OPERATION PERMIT

*CDP File Number 366073 - 1

4-Bedroom Septic Layout
Lot 21, High Croft Subdivision
Franklin County, North Carolina

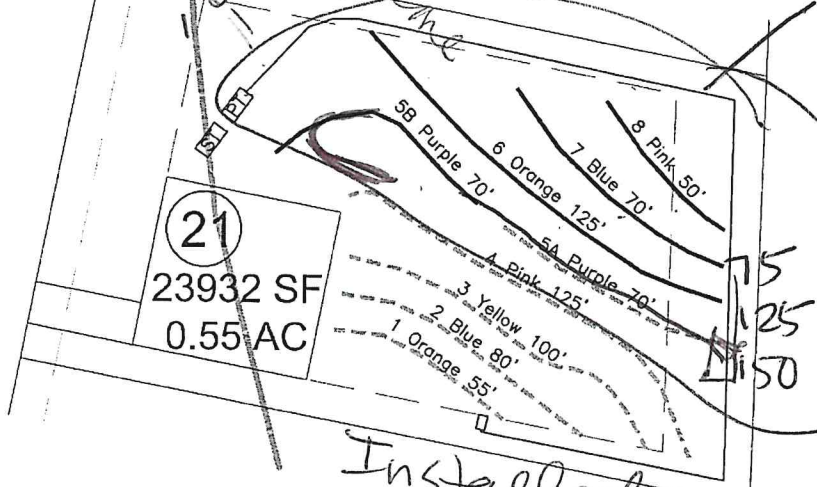
New design on lot.

Installed Repair Area (switched)
Old design

As built from new design

Patio addition was reason for change
